MITSUBISHI MOTORS CORPORATION

NEWS LETTER

Model: CK-6G7GDI	Date: Jan. 18, 2002			Nº: 02 - 008		
	Distribution No. by market					
Group: FUEL (13)	G. EXP	EUR	MMAL	CHRY.	MMSA	US TERR.
	-----	02	-----	-----	-----	-----

Subject: **Repair procedure for poor acceleration, lack of power and low peak out**

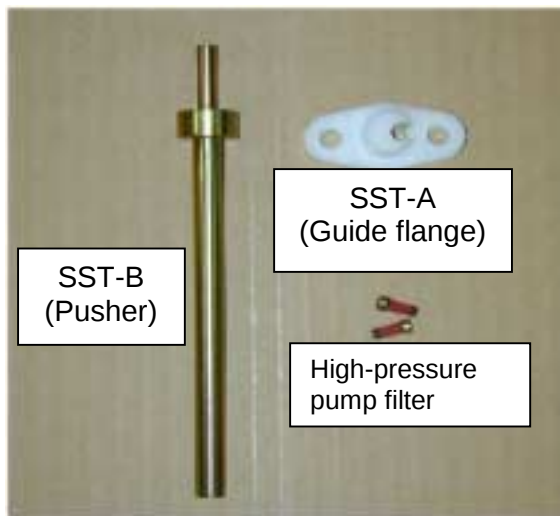
4. Remove the engine cover and all the parts shown in the following picture.

5. Remove 2 fixing bolts of the fuel pressure hose connection flange.
Cope with seeping fuel and clean up the fixing base.

[Special service tool]

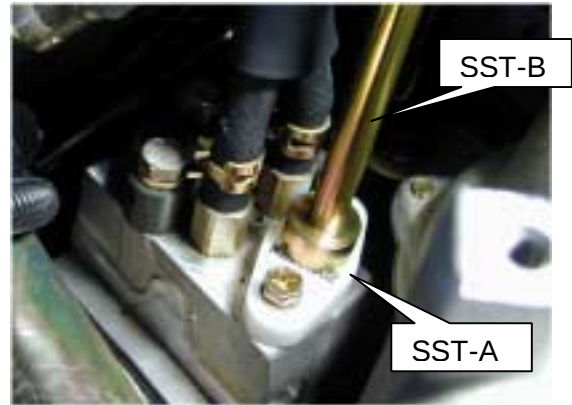
6. Set the SST-A on the fixing block for the fuel pressure hose as shown in the following picture.

7. Screw the SST-C in the guide hole **completely to the end**, and pull out the existing filter **at one go-off**.

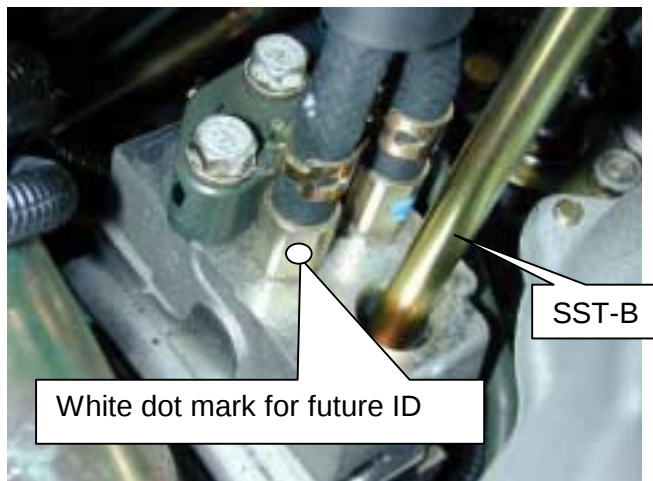
8. Insert a new filter (MD619962) in the guide hole of the SST-A, and gently hammer it in with the small end of SST-B to the end.
